# Engineering Policy Ballot

Effective: October 1, 2025

# ENGINEERING POLICY BALLOT

**Effective:**    **October 1, 2025**

Figure 712.1.5.4.1.5, Copy of Test Report for TNA Fixed Spline Structural Bolting Assembly

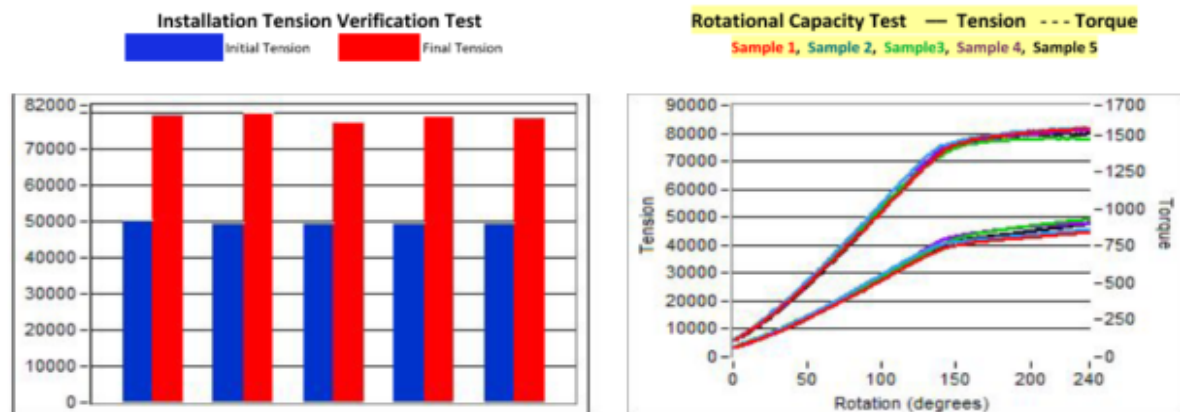
Figure 712.1.5.4.1.1, ~~and 712.1.5.4.1.2 and 712.1.5.4.1.3 below are of bolt heads to~~ show different types of bolt heads. ~~and~~ Figure 712.1.5.4.1.4 shows a copy of a common shipping form-certified material test report that provides testing verification of the bolts. ~~and~~ Figure 712.1.5.4.1.5 shows a copy of a common Test Report for a Torque and Angle (TNA) fixed spline bolt assembly.

### Coating New Truss Bridges or Other Unusual Structures

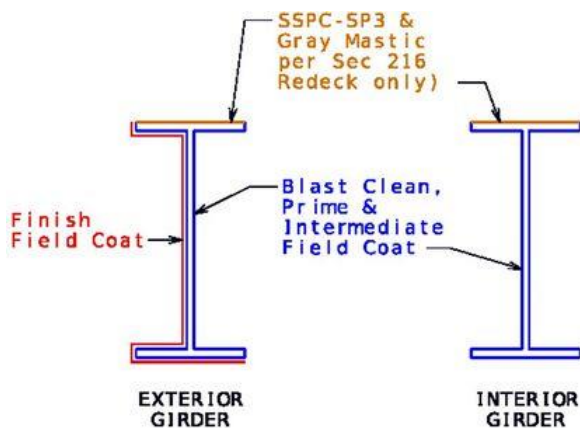
Intermediate Field Coat and Finish Field Coat (System G, H, ~~I~~ or ~~L~~) (Gray or ~~b~~Brown) - The quantity shall be computed as a lump sum quantity.

All structural steel for truss or steel box girder spans shall be field coated with intermediate and finish coats, except the area of steel to be in contact with concrete, ~~and~~ ~~I~~Intermediate field coat is not required when System I ~~or L~~ is specified.
